RE: Monterey Baptist Church
12501 Lomas Blvd NE
Request Permanent C.O. - Approved
Engineers Stamp Date 6/17/15 (J22D012A)
Certification date: 3-16-16

**RE: Monterey Baptist Church
12501 Lomas Blvd NE
Request 90-Day Temporary C.O. - Approved
Engineers Stamp Date 6/17/15 (J22D012A)**

**RE: Monterey Baptist Church
12501 Lomas Blvd NE
Grading and Drainage Plan
Engineers Stamp Date 6/17/15 (J22D012A)**

**RE: Grading and Drainage Plan
Monterey Baptist Church (J22/D012A)**

Site Grading and Drainage Plan

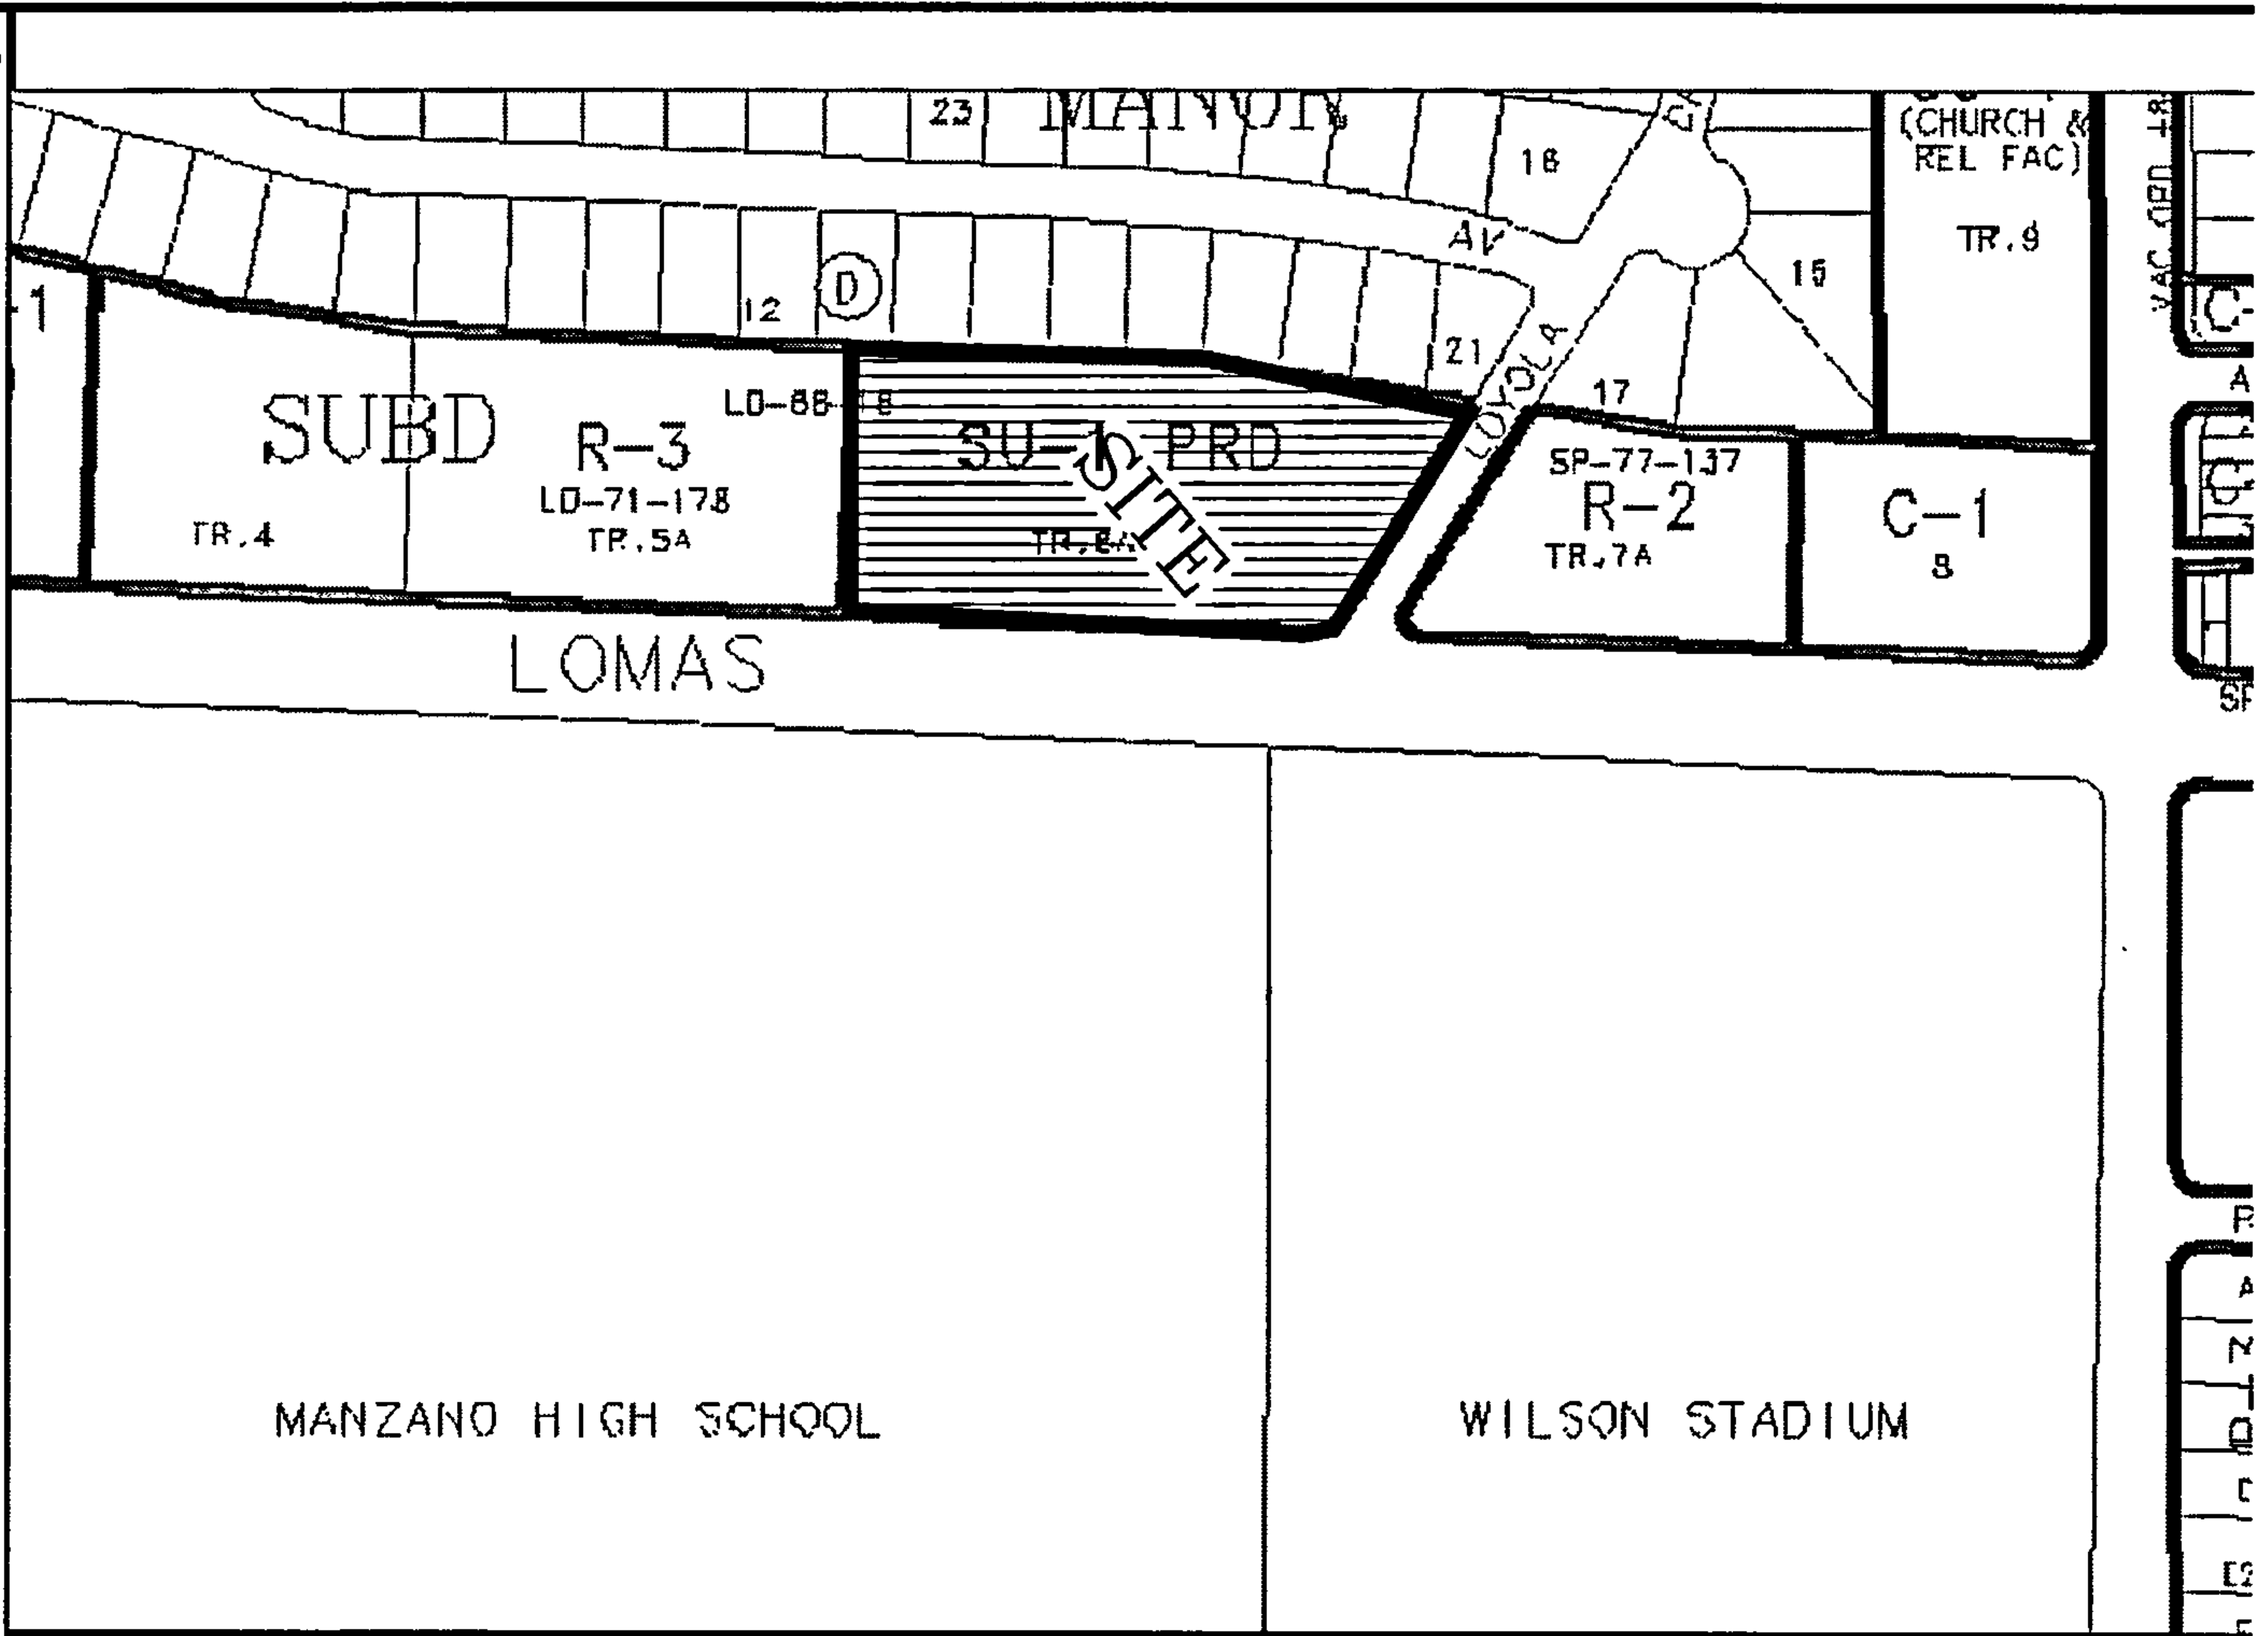
3. Basin C appear to drain across sidewalk, provide swale to pond.

A cobble swale has been added along the south property line. This swale directs all flows to the pond.
